New Albany Architectural Review Board Agenda
Monday, August 08, 2022 7:00pm

**Architectural Review Board Staff Report
August 8, 2022**

**14 SOUTH HIGH STREET BUILDING ADDITION
CERTIFICATE OF APPROPRIATENESS**

LOCATION: 14 South High Street (PID: 222-000001)
APPLICANT: Keiser Design Group Inc, c/o Ethan Frazier
REQUEST: Certificate of Appropriateness
ZONING: Urban Center, Historic Center
STRATEGIC PLAN: Village Center
APPLICATION: ARB-84-2022

14 S. HIGH ST., NEW ALBANY, OH 43054
PROPOSED EXTERIOR ELEVATIONS

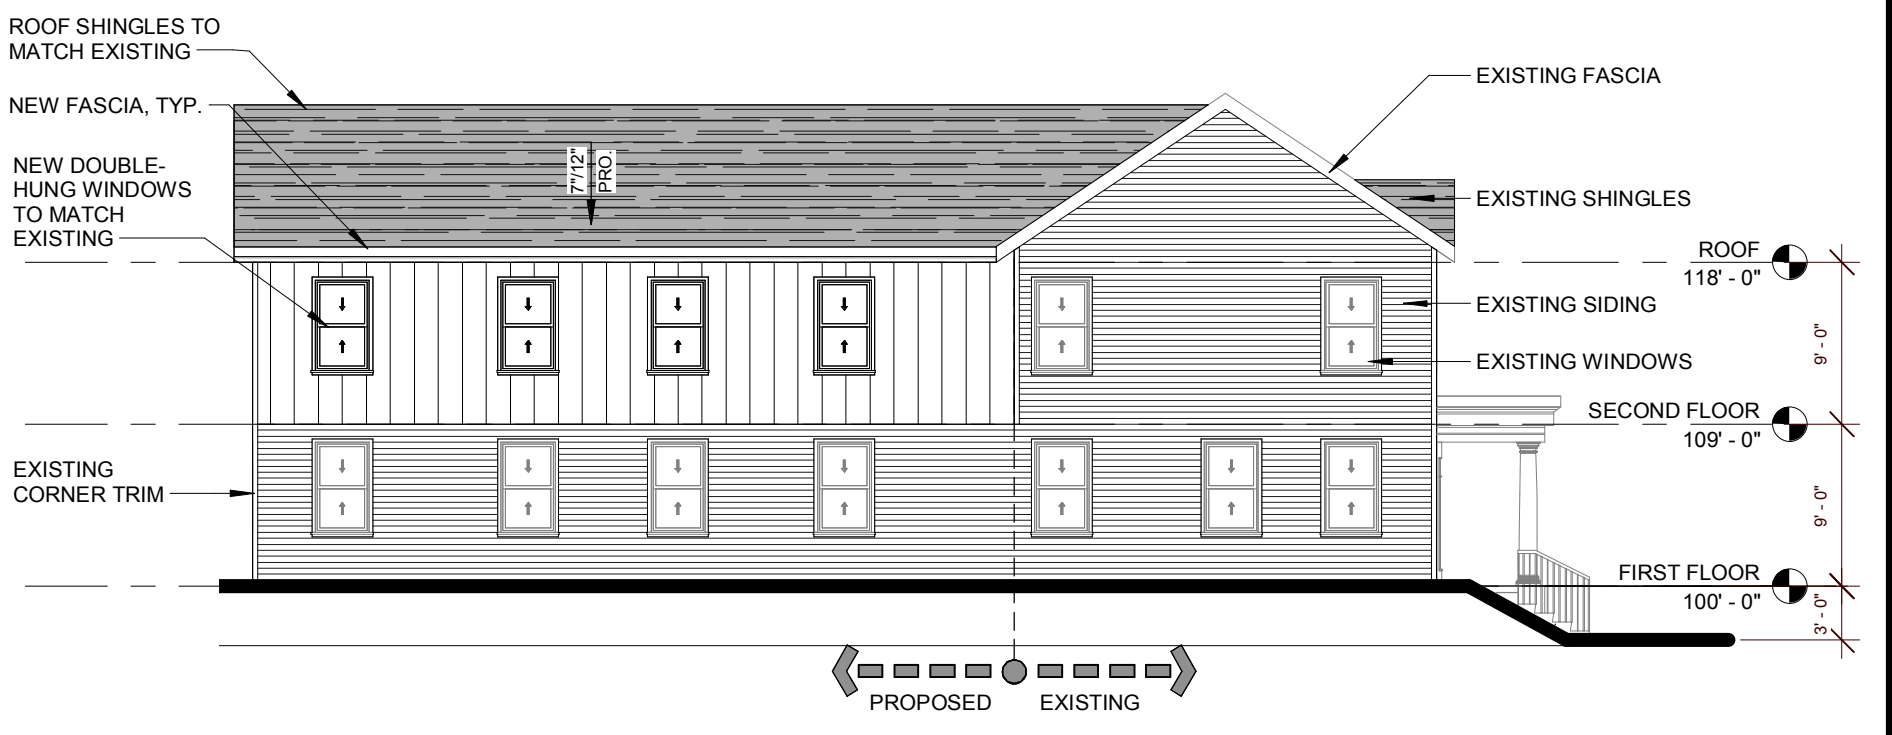
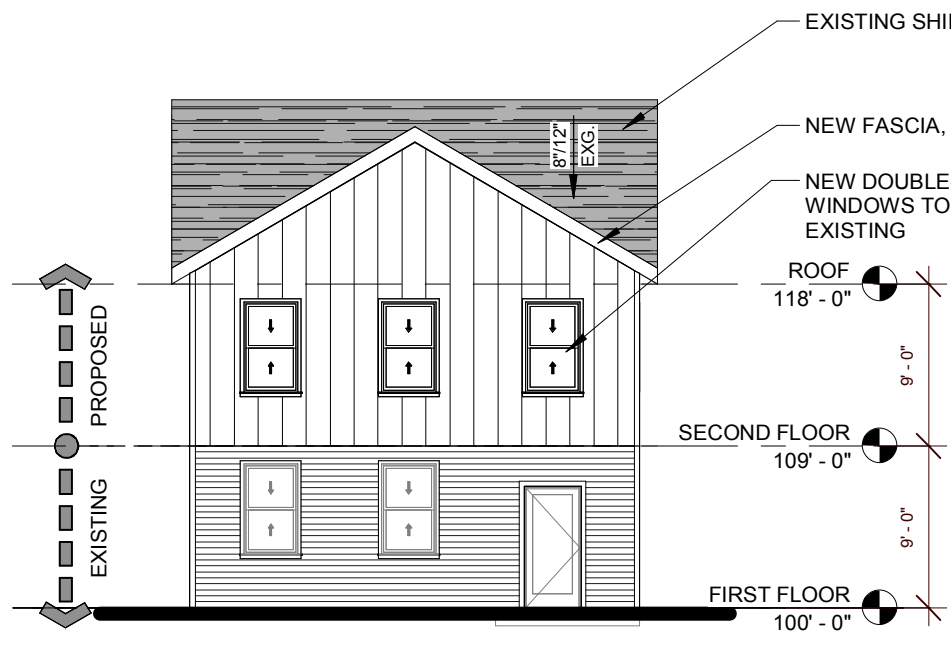
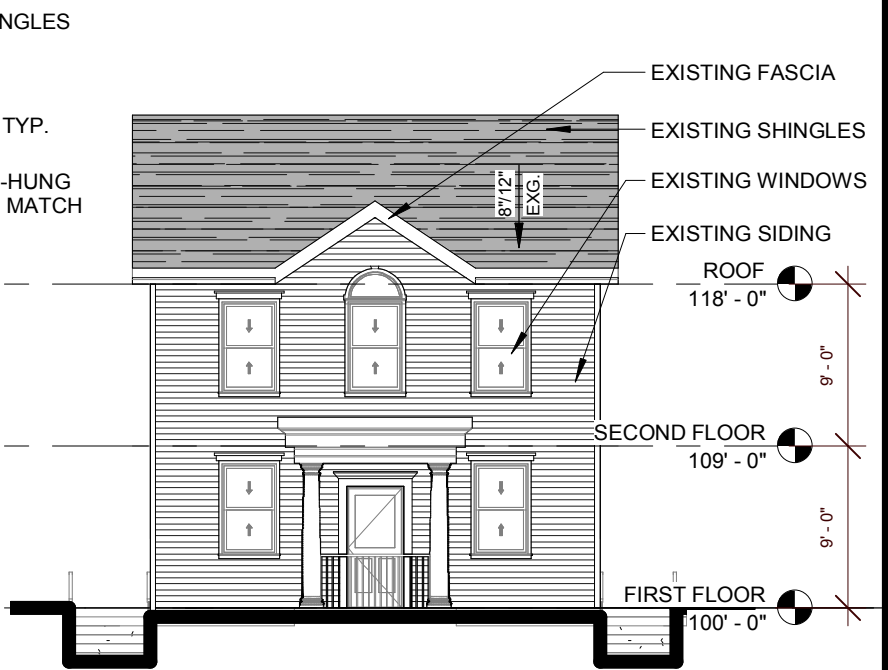
- The new two-story wall will be flush with the side wall of the original structure. The new fascia matches the existing fascia. The plans include new double-hung windows to match the existing windows. The applicant proposes to utilize gray roof shingles on the addition that match the existing shingles. The applicant included a digital sample material board with their application documents.

- The city architect has reviewed the application and comments that since the addition is a full two-story height structure, it doesn't feel as if the renovation relates to the existing design as much as it should. The city architect recommends the following revisions:

- The visual break between the existing portion and new addition needs to happen at the eave.
 - The roof pitch of the existing structure and new addition are to match.

- Shed roof dormers are to be added with a 4:12 pitch.

- The addition is to have a 7' tall knee wall between the existing one-story portion of the structure and the new roof for the addition.
- Staff recommends a condition of approval that all comments from the city architect are satisfied, subject to staff approval. The city architect created the following sketch to indicate what additional detailing he recommends:

- The city architect’s rendering above shows how they recommend to visually separate the existing and new eave lines, in order to maintain a hierarchy of the original main building shape. This rendering, along with the city architect’s comments, were provided to the applicant. The applicant responded by stating the property owner agrees to the revisions proposed by the city architect and they intend to provide updated renderings at the board meeting.

- Design Guidelines and Requirements (DGR) Section 4(I.B.3) states that “additions shall be designed in a way that does not obscure, destroy or otherwise compromise the character and design of the existing building.” Additionally, section 2 (II.B.2) states “building designs shall not mix elements from different styles.” DGR Section 4(I.B.4) states that additions shall employ similar materials to those that predominate in existing structures. With the recommended changes from the city architect, this requirement will be met.

- DGR section 2(II.C.3) states “the height of building wings and dependencies shall not exceed the height of the roof peak of the main portion of the building.” Based on the recommended changes from the city architect, this requirement will be met.

1. That the applicant must revise the design and drawings per the city architect's comments and the rendering provided, subject to staff approval.
2. The existing horizontal vinyl siding be replaced with horizontal Hardie board material.

DIGITAL SAMPLE MATERIAL BOARD

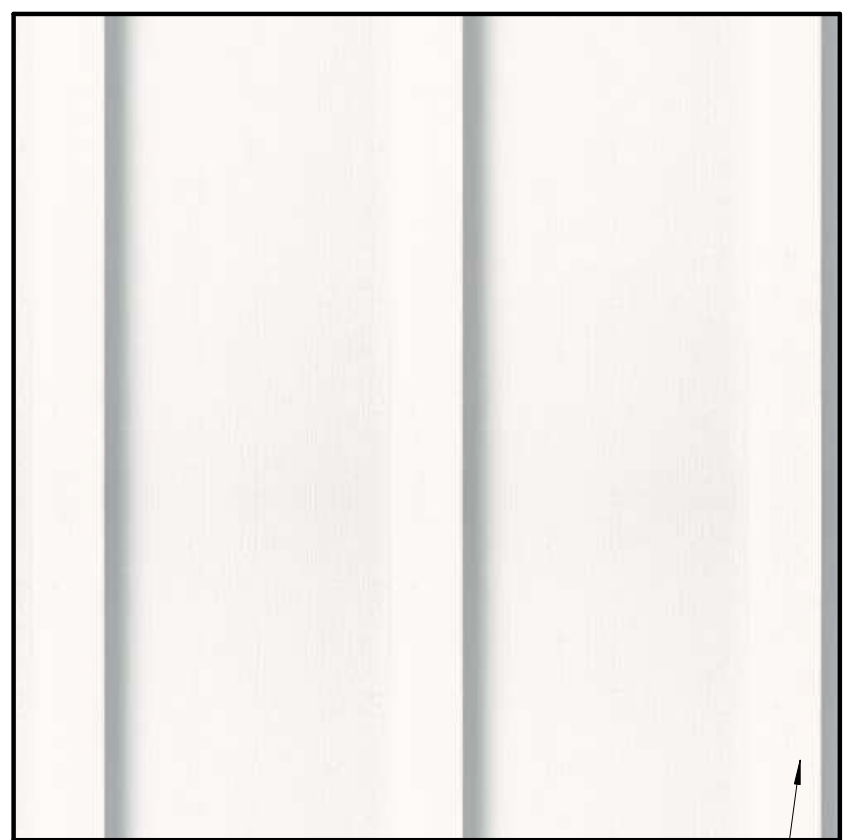
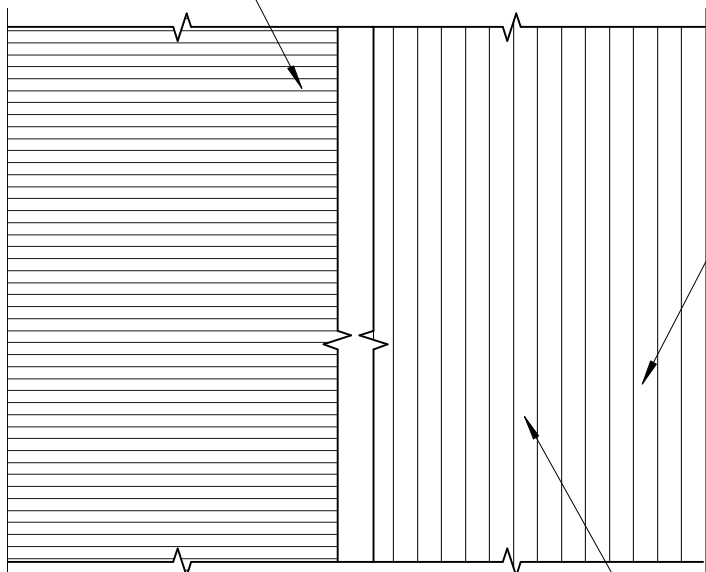
- The applicant proposes a white board and batten style siding on the addition that is consistent with the way traditional materials would have been used. The applicant proposes to use Hardie panel board (fiber cement) for the boards and thin strips of wood molding for battens. A digital sample material board has been submitted which shows the proposed Hardie panel board material having similar surface texture as wood. Hardie panel board has been used successfully in other parts of the Village Center.

- The applicant proposes to remove and replace the existing vinyl siding with Hardie panel board and batten on the existing portions of the building.
 - The city architect recommends that the applicant retain the horizontal siding pattern with new Hardie board material. The city architect states that this approach helps to differentiate between old and new.

- Staff supports the request to replace the existing vinyl siding with the Hardie board material since it mimics wood material. Hardie panel board has been used successfully in other parts of the Village Center.

- Based on the city architect's comment, staff recommends a condition of approval that the existing horizontal vinyl siding be replaced with horizontal Hardie board material.
